**INTERNATIONAL STANDARD ISO/IEC 15444-1:2000**

TECHNICAL CORRIGENDUM 2

# Information technology — JPEG 2000 image coding system —

## Part 1:
## Core coding system

**Figure I-11 — Organization of the contents of the Palette box**

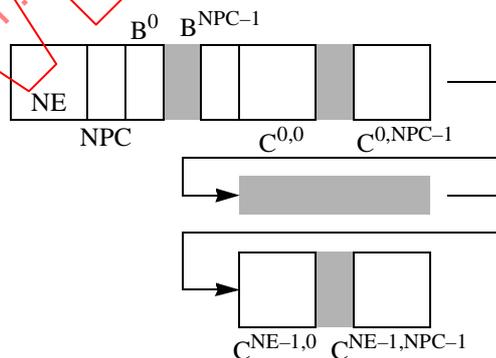
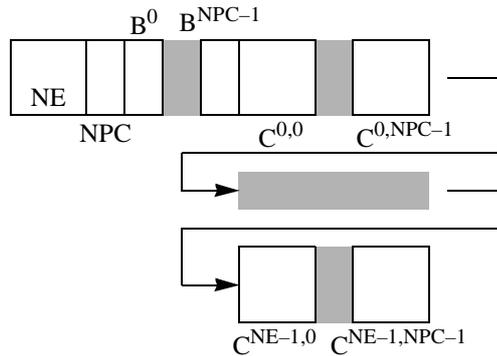
21) In Annex I.5.3.4, change "

The palette specified in this box is applied to a single component to convert it into multiple components. The colourspace of the components generated by the palette is then interpreted based on the values of the Colour Specification boxes in the JP2 Header box in the file. The mapping of an actual component from the codestream through the palette is specified in the Component Mapping box. If the JP2 Header box contains a Palette box, then it shall also contain a Component Mapping box. If the JP2 Header box does not contain a Palette box, then it shall not contain a Component Mapping box.

**NE:**    Number of entries in the table. This value shall be in the range 1 to 1 024 and is encoded as a 2-byte big endian unsigned integer.

**NPC:** Number of components created by the application of the palette. For example, if the palette turns a single index component into a three-component RGB image, then the value of this field shall be 3. This field is encoded as a 1-byte unsigned integer.

**B$^i$:** This parameter specifies the bit depth of generated component $i$, encoded as a 1-byte big endian integer. The low 7-bits of the value indicate the bit depth of this component. The high-bit indicates whether the component is signed or unsigned. If the high-bit is 1, then the component contains signed values. If the high-bit is 0, then the component contains unsigned values. The number of B$^i$ values shall be the same as the value of the NPC field.

**C$^{ji}$:** The generated component value for entry $j$ for component $i$. C$^{ji}$ values are organized in component major order; all of the component values for entry $j$ are grouped together, followed by all of the entries for component $j+1$. The size of C$^{ji}$ is the value specified by field B$^i$. The number of components shall be the same as the NPC field. The number of C$^{ji}$ values shall be the number of created components (the NPC field) times the number of entries in the palette (NE). If the value of B$^i$ is not a multiple of 8, then each C$^{ji}$ value is padded with zeros to a multiple of 8 bits and the actual value shall be stored in the low-order bits of the padded value. For example, if the value of B$^i$ is 10 bits, then the individual C$^{ji}$ values shall be stored in the low 10 bits of a 16 bit field.

### I.5.3.4    Palette box

This box specifies a palette that can be used to create channels from components. However, the Palette box does not specify the creation of any particular channel; the creation of channels based on the application of the palette to a component is specified by the Component Mapping box. The colourspace or meaning of the generated channel is specified by the Channel Definition box (or specified through the defaults defined in the specification of the Channel Definition box if the Channel Definition box does not exist). If the JP2 Header box contains a Palette box, then it shall also contain a Component Mapping box. If the JP2 Header box does not contain a Palette box, then it shall not contain a Component Mapping box.

**Figure I-11 — Organization of the contents of the Palette box**

**NE:**  Number of entries in the table. This value shall be in the range 1 to 1 024 and is encoded as a 2-byte big endian unsigned integer.

**NPC:**  Number of palette columns specified in the Palette box. For example, if the palette is to be used to map a single index component into a three-component RGB image, then the value of this field shall be 3. This field is encoded as a 1-byte unsigned integer.

**$B^i$:**  This parameter specifies the bit depth of values created by palette column $i$, encoded as a 1-byte big endian integer. The low 7-bits of the value indicate the bit depth of this palette column. The high-bit indicates whether the palette column is signed or unsigned. If the high-bit is 1, then the palette column contains signed values. If the high-bit is 0, then the palette column contains unsigned values. The number of $B^i$ values shall be the same as the value of the NPC field.

**$C^{ji}$:**  The value for entry $j$ for palette column $i$. $C^{ji}$ values are organized in entry major order; all of the values for entry $j$ are grouped together, followed by all of the values for entry $j+1$. In the example given above, this table would therefore read $R_1, G_1, B_1, R_2, G_2, B_2$, etc. The size of $C^{ji}$ is the value specified by field $B^i$. The number of palette columns shall be the same as the NPC field. The number of $C^{ji}$ values shall be the number of palette columns (the NPC field) times the number of entries in the palette (NE). If the value of $B^i$ is not a multiple of 8, then each $C^{ji}$ value is padded with zeros to a multiple of 8 bits and the actual value shall be stored in the low-order bits of the padded value. For example, if the value of $B^i$ is 10 bits, then the individual $C^{ji}$ values shall be stored in the low 10 bits of a 16 bit field.
